OIL CONSERVATION COMMISSION  
Capitan DISTRICT

RE: Proposed MC \_\_\_\_\_  
Proposed DHC ☒ \_\_\_\_\_  
Proposed NSL \_\_\_\_\_  
Proposed SWD \_\_\_\_\_  
Proposed WFX \_\_\_\_\_  
Proposed PMX \_\_\_\_\_

I have examined the application dated 12-4-78  
for the Getty Oil Co. Jicarilla B #5 L-32-25N-5W  
Operator Lease and Well No. Unit, S-T-R

Subject: Administrative Approval  
For Commingling

Jicarilla "B" Well No. 5  
 1650' FSL, 600' FWL, Sec. 32-25N-5W  
 Rio Arriba County, New Mexico  
 Elev. 6700' KB

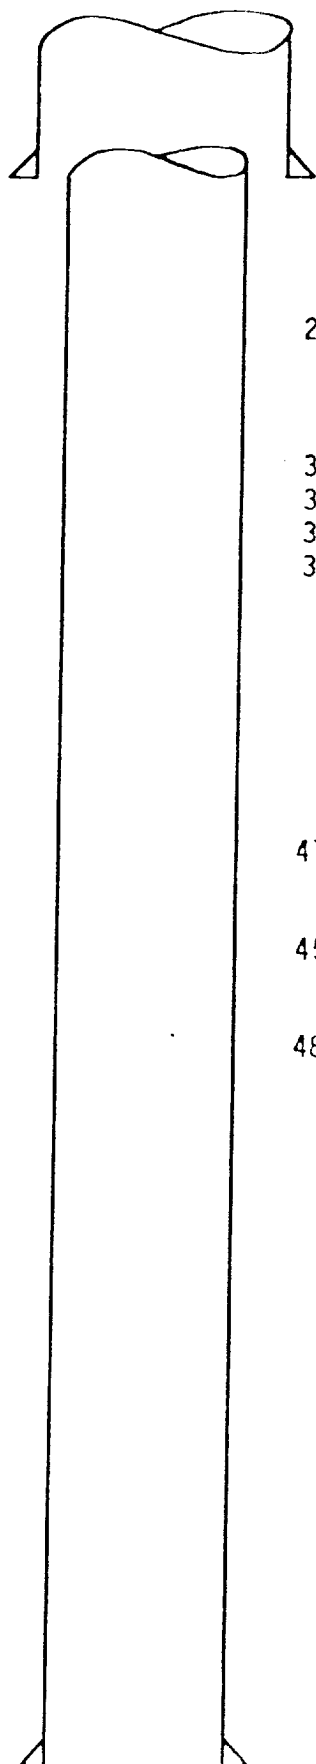
Approve R-5388-A  
\_\_\_\_\_  
\_\_\_\_\_  
\_\_\_\_\_  
\_\_\_\_\_  
\_\_\_\_\_
